ENGINEERING CHANGE NOTICE NO.

04765

DWG NO. 646.3300

DWG TITLE: UPPER CUTTER ASSY

SHEET 5 IS:

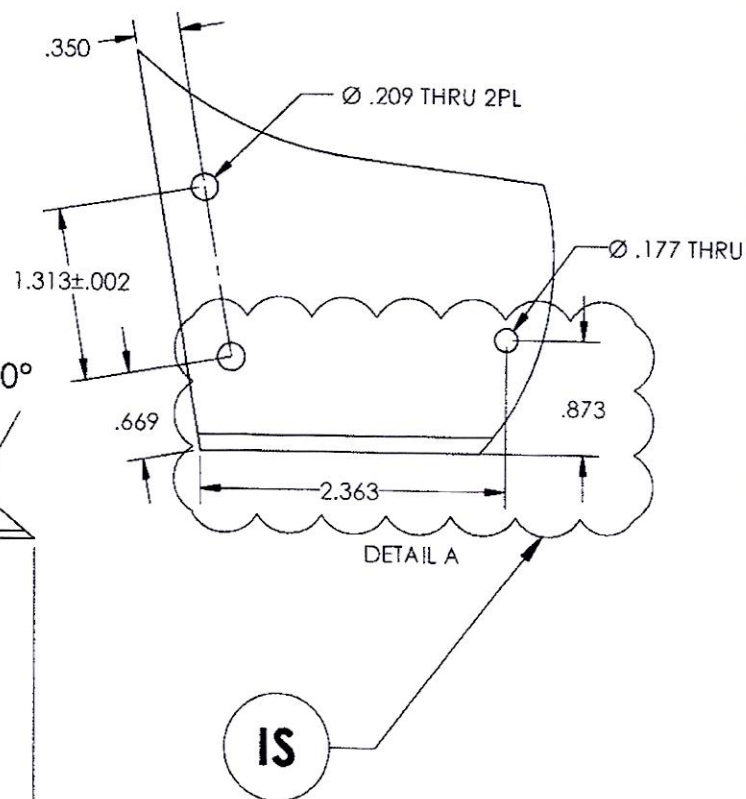
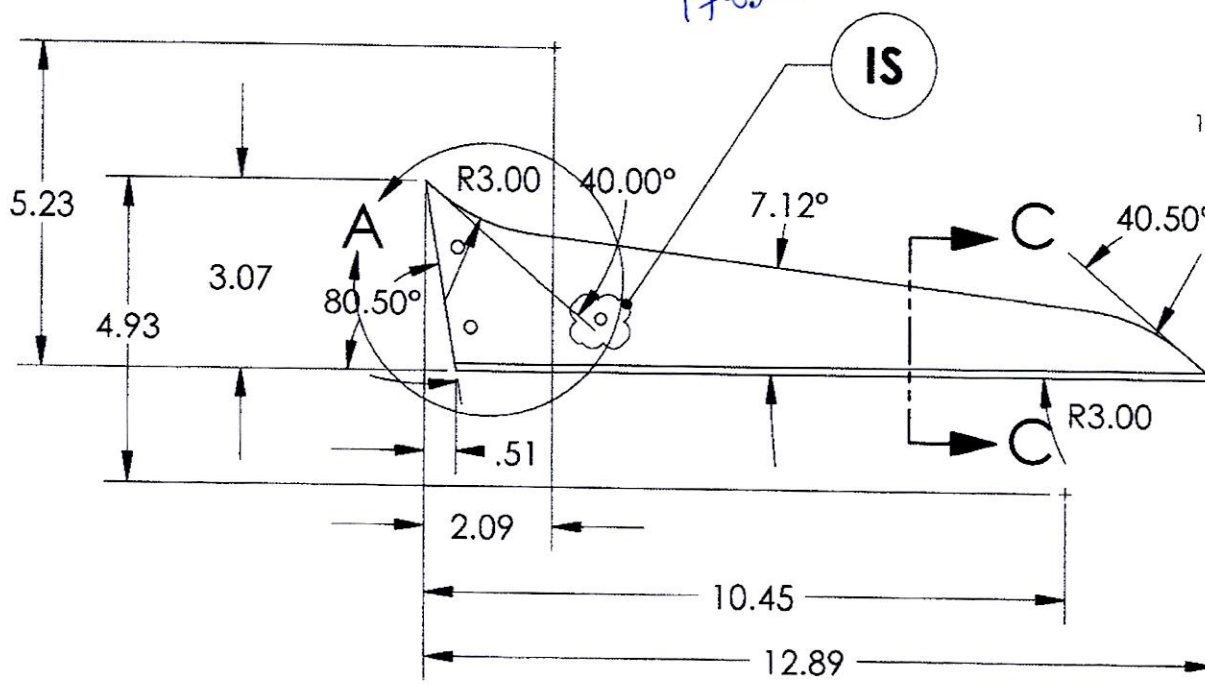
REASON: ADDED HOLE DIMENSION TO 646.3313.

SHEET 4, ZONE B8 IS:

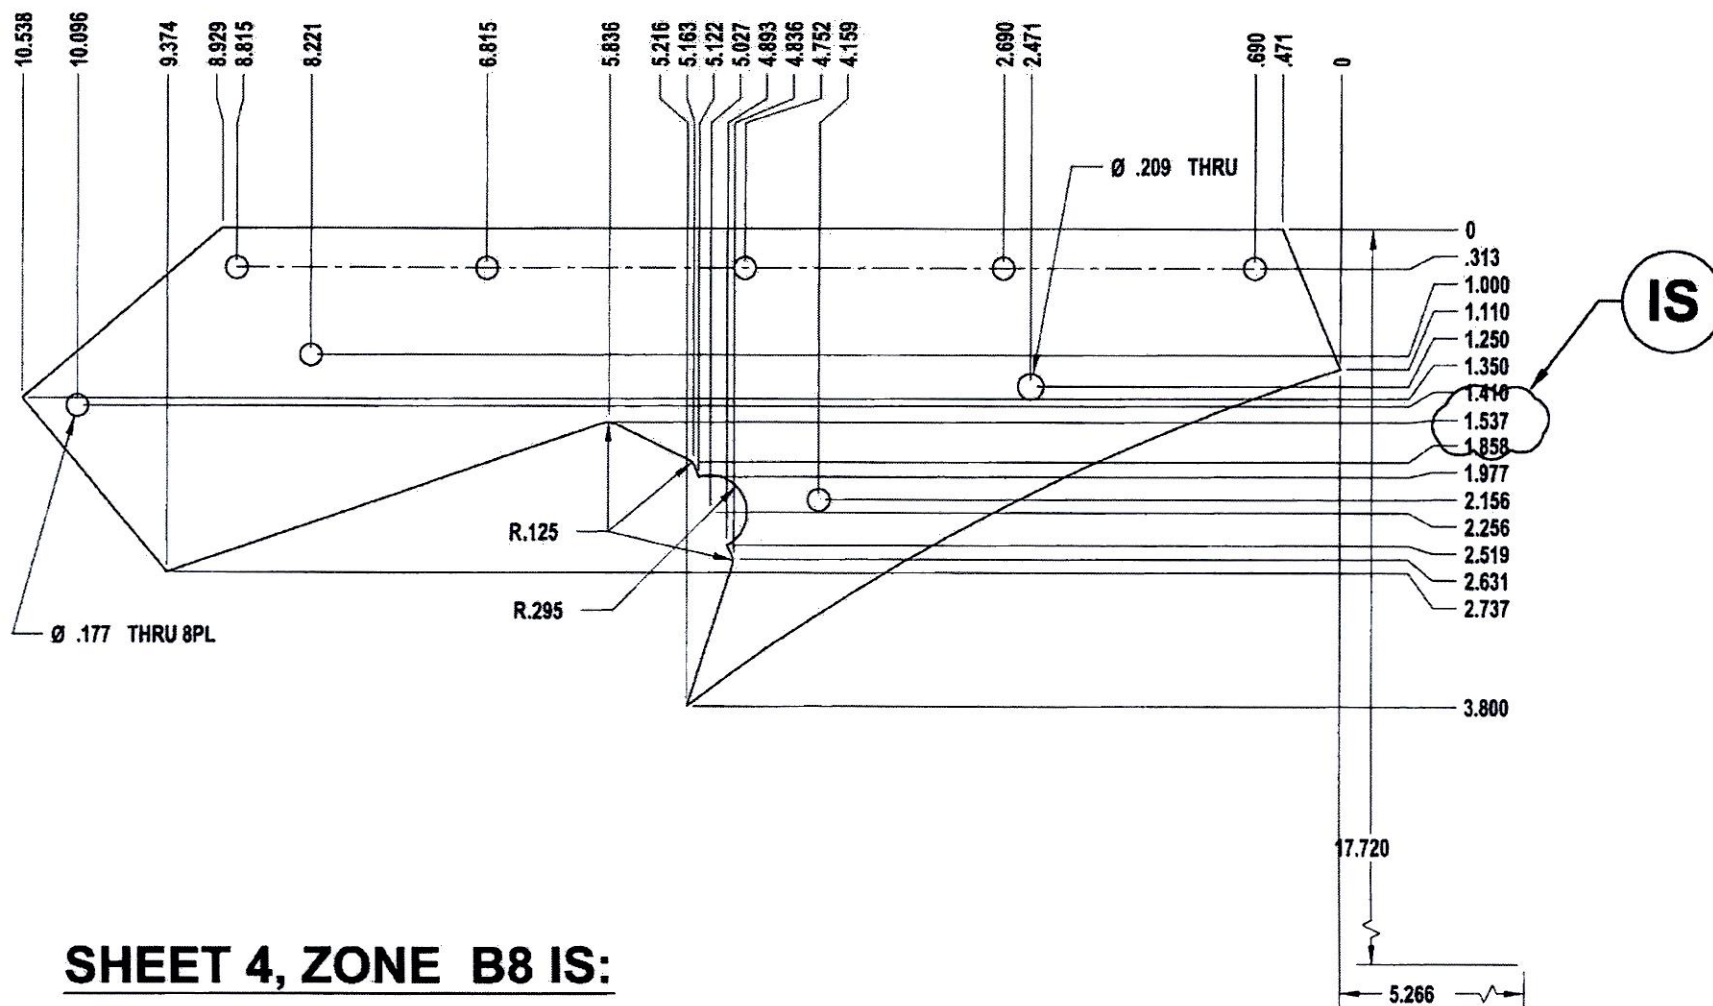
APICAL INDUSTRIES, INC.	ENGINEERING CHANGE NOTICE NO. 03724				SHEET 1 OF 1	
	DWG NO. 646.3300	REV: N/C	PREPARED BY B. PETERS	DATE: 12/05/12	EFFECT ON DWG ☐ INC. ☒ UNINC.	
	DWG TITLE: UPPER CUTTER ASSY					
APPROVED BY: ENGR <i>[Signature]</i>		MFG <i>[Signature]</i>		QC <i>[Signature]</i>	EFF: NEXT ORDER	
TRANSACTION CODES (TC): A-ADD C-CREATE R-REVISE D-DELETE		REASON: REVISED ORDINATE DIMENSION.				ECR: D-12-025

SHEET 1, VIEW 646.3301, IS:

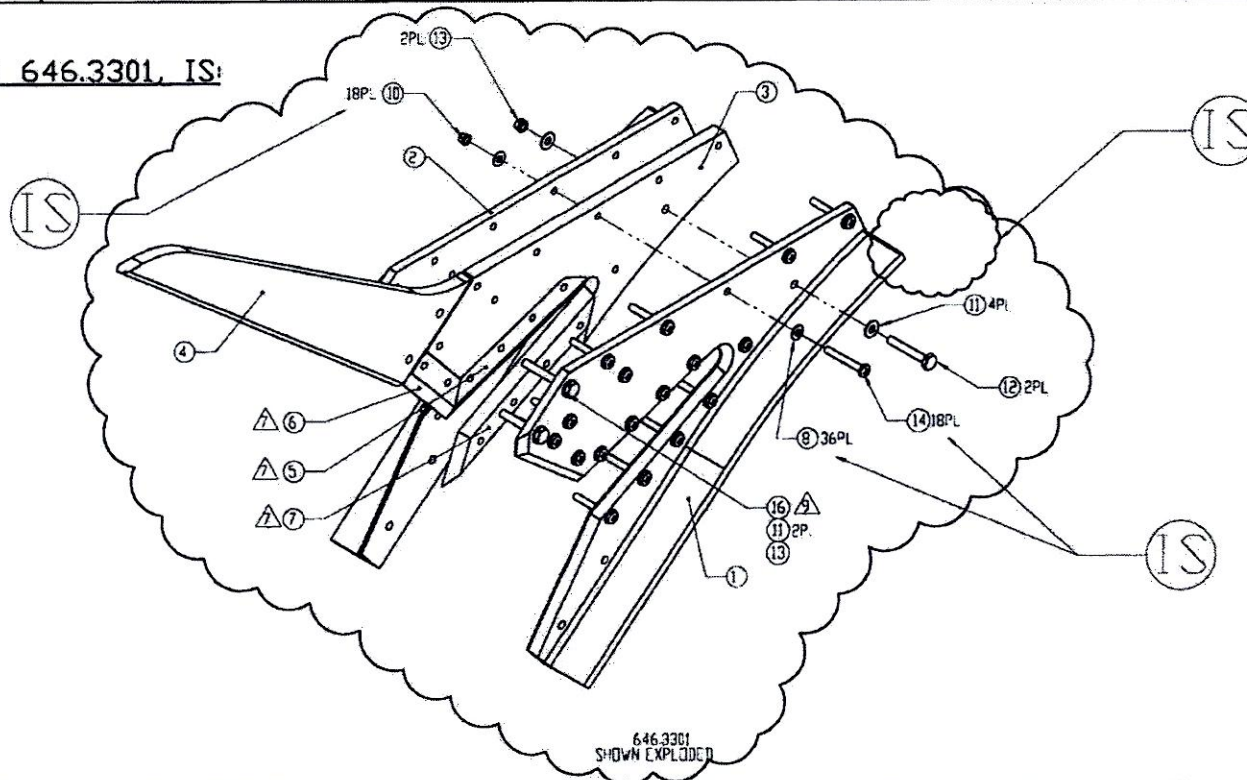
APICAL INDUSTRIES, INC.	ENGINEERING CHANGE NOTICE NO. 02196			SHEET 1 OF 2	
	DWG NO. 646.3300	REV: N/C	PREPARED BY S. HUFF	DATE: 01/05/09	EFFECT ON DWG ☐ INC. ☒ UNINC.
	DWG TITLE: UPPER CUTTER ASSY				
	APPROVED BY: ENGR <i>[Signature]</i>	MFG: <i>[Signature]</i>	QC: <i>[Signature]</i>	EFF: <i>[Signature]</i>	NEXT ORDER
TRANSACTION CODES (TC): A-ADD C-CREATE R-REVISE D-DELETE					
REASON: REMOVED RIVETS IN FAVOR OF ADDITIONAL SCREWS

14	R	601.2765	18	SCREW	MS27039-0819
10	R	601.1541	18	LOCKNUT	MS21042L08
9	D	601.2766	3	RIVET	MS20470AD5-18
8	R	601.2764	36	WASHER	NAS1149FN832P
			.3301		
F/N	TC	PART NUMBER	QTY	DESCRIPTION	MATERIAL/SPECIFICATION
DOCUMENTS EFFECTED:					CHANGE CATEGORY ☐ MAJOR ☒ MINOR
☐ MDL ☒ INSTALL INSTRU ☒ ICA ☐ FMS ☒ BOM					DER REVIEW REQUIRED ☐ YES ☒ NO
